SUBJECT: Responds to NRC 840813 Questions 5a, b & c in request for
 addl info re application for amend to Licenses DPR-31 &
 DPR-41, changing structural design of spent fuel pit & new
 storage racks.

Re: Turkey Points Units 3 & 4
Docket Nos. 50-250 & 50-251
Proposed Amendment to
Spent Fuel Storage Facility Expansion
Additional Information

FLORIDA POWER & LIGHT COMPANY
TURKEY POINT UNITS 3 & 4
PROPOSED AMENDMENT TO SPENT FUEL
STORAGE FACILITY EXPANSION
SUPPLEMENT TO REQUEST FOR ADDITIONAL
INFORMATION - STRUCTURAL BRANCH

FIGURE 1

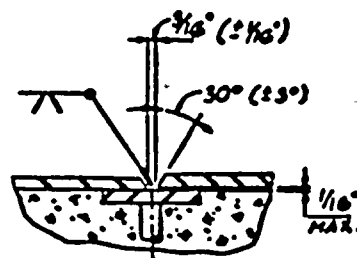
12. Please discuss the design of the weld connections between the stainless steel liner plates.

In support of the leak prevention function, the liner plates are welded to each other or to embedded plates using seam welds which were sized for hydrostatic and thermal loads. Vertical seams in the wall liner plates are square butt or bevel butt welds with embedded 1/4" x 2" continuous bars serving as backing bars (Figures 1 and 2). Horizontal seams in the wall liner plates are fillet welds between the plate edges and the embedded 1/4" x 21" continuous bars (Figure 3). Seams in the floor liner plate are fillet welds between plate edges and embedded plates or bars. In the cask laydown area, the surfaces of the seams are maintained flush with the floor by use of 1/4" square filler bars and bevel filler welds (Figure 4). The seam details in other areas of the floor are similar, except that the filler bar used is 1/2" x 3/8" (Figure 5); This results in the top of the seam projecting above the floor surface.
